FAQ 20-05: RBS Unplanned Scram May 2019
Final Approved

Plant: River Bend Station, Unit 1
Date of Event: 5/31/2019
Submittal Date: October 09, 2020
Licensee contact: Timothy Schenk Tel/email: 225-381-4177 / tschenk@entergy.com
NRC Contact: Raymond Kumana Tel/email: 817-200-1970 / rkuma94@entergy.com

Performance Indicator: IE04 - Unplanned Scrams with Complications (USwC)

IE04 Unplanned Scrams with Complications - Flowchart
Figure 2

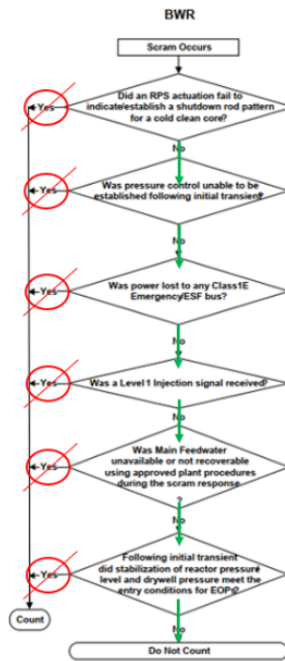
Based upon the above timeline and NEI 99-02 Rev. 7 definitions, RBS was outside the "Scram Response Time" by 30 minutes before the subsequent level three scram signal and therefore did not have an Unplanned Scram with Complications. Additionally, the below flowchart demonstrates this conclusion as seen in NEI 99-02 Rev.7, Figure 2.

The resident inspectors believe the May 31, 2019 scram is an unplanned scram with complications based on answering “Yes” to NEI 99-01 Revision 7, “IE04 Unplanned Scrams with Complications – Flowchart” questions #5 and #6.

On Question #5, “Was main feedwater unavailable or not recoverable using approved plant procedures during the scram response”, the resident believes the answer is “Yes.” The resident takes the word “recoverable” in the sentence to mean recoverable in a sustainable manner. Main feedwater was not recoverable in a sustainable manner using approved plant procedures because approved plant procedures did not instruct operators to un-isolate the heater string when bringing the feed pump back online. In using approved plant procedures, operators failed to un-isolate the heater string during their initial start of the feed pump. Consequently, when they secured the condensate pump per procedure, they caused the feed pump to trip, resulting in a low-level scram signal and an EOP re-entry.

In conclusion, upon reviewing the event details, prior applicable FAQs, and discussing the circumstances surrounding the May 31st, 2019 reactor scram, the staff determined that this event should be classified as an Unplanned Scram with Complications (IE03). No changes to NEI 99-02 needed as a result of this FAQ.
